ADDENDUM NO.   1   DATED   3/20/2012   ADDENDUM NO. \_\_\_\_\_ DATED \_\_\_\_\_  
 ADDENDUM NO. \_\_\_\_\_ DATED \_\_\_\_\_ ADDENDUM NO. \_\_\_\_\_ DATED \_\_\_\_\_

APD-0070-05(024)N / 100078305 APD-0070-06(025)N / 100078306 & 307 Pontotoc and Lee County(ies)

**PROJECT: APD-0070-05(024)N / 100078305 and APD-0070-06(025)N / 100078306 & 307  
-- Pontotoc and Lee Counties**

**SECTION 904 - NOTICE TO BIDDERS NO. 3585**

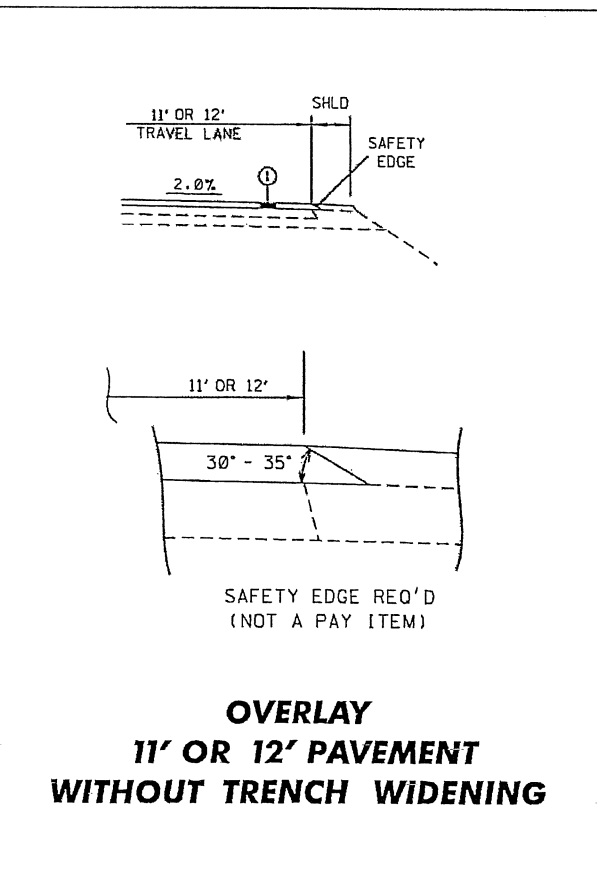
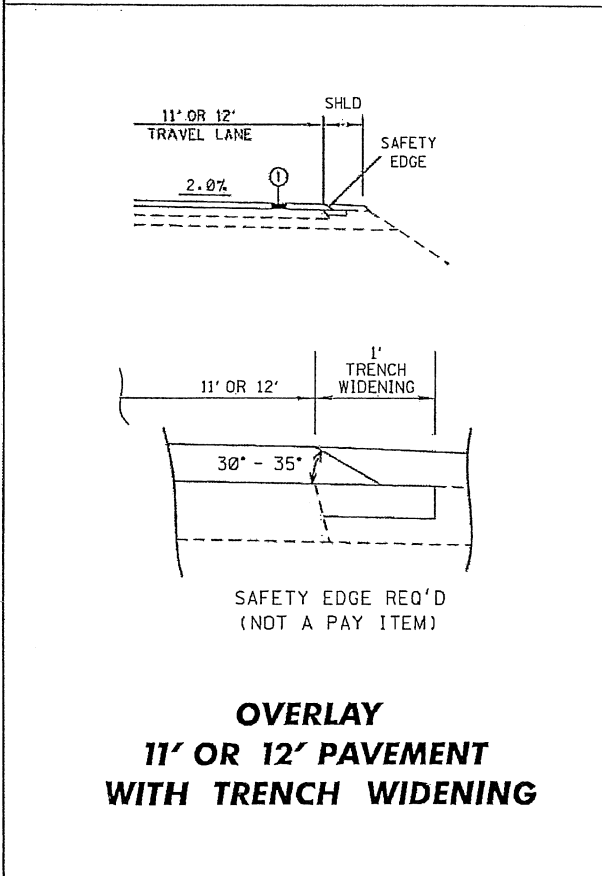
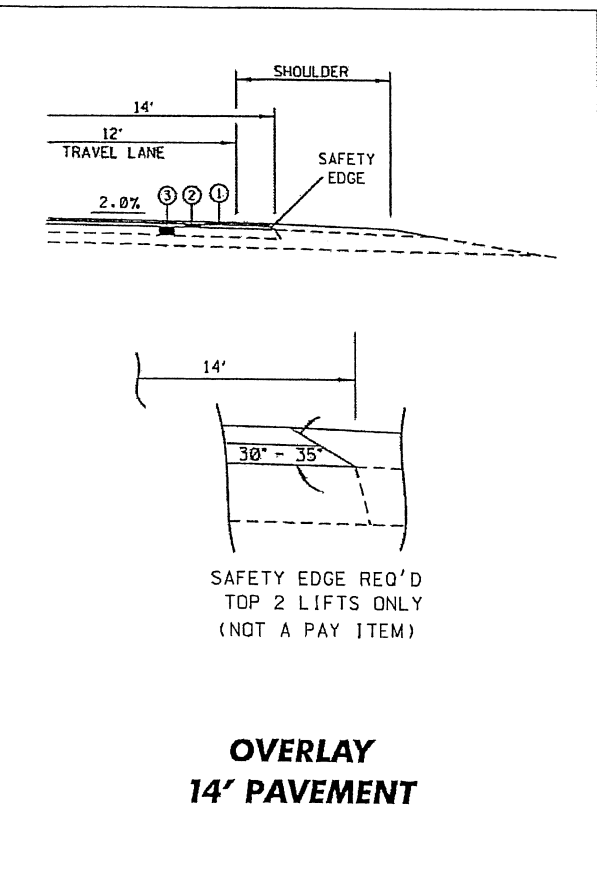
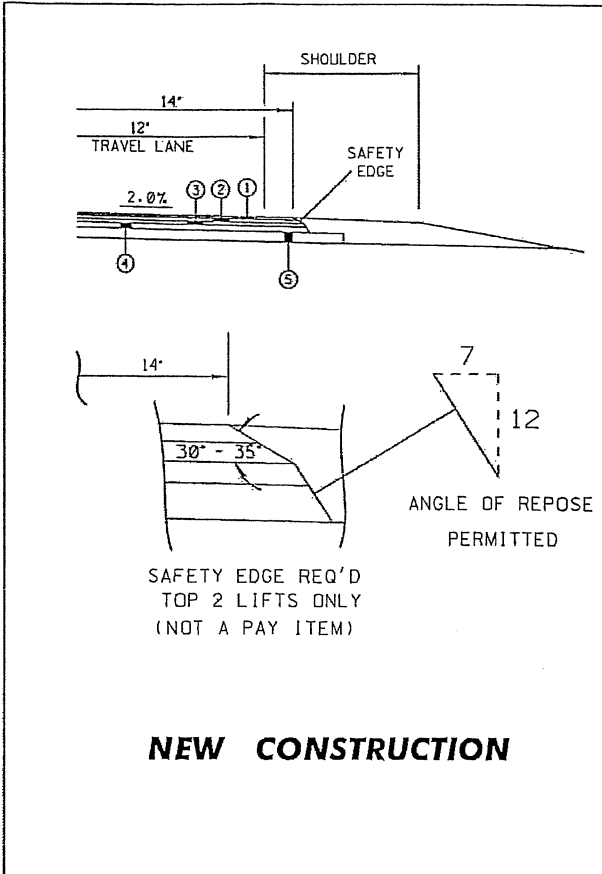
Bidders are hereby advised that the Shoulder Wedge (Safety Edge) specified in the Supplement to Special Provision 907-401-2 shall only apply to the top two (2) lifts of asphalt. Attached is a drawing showing the safety edge.
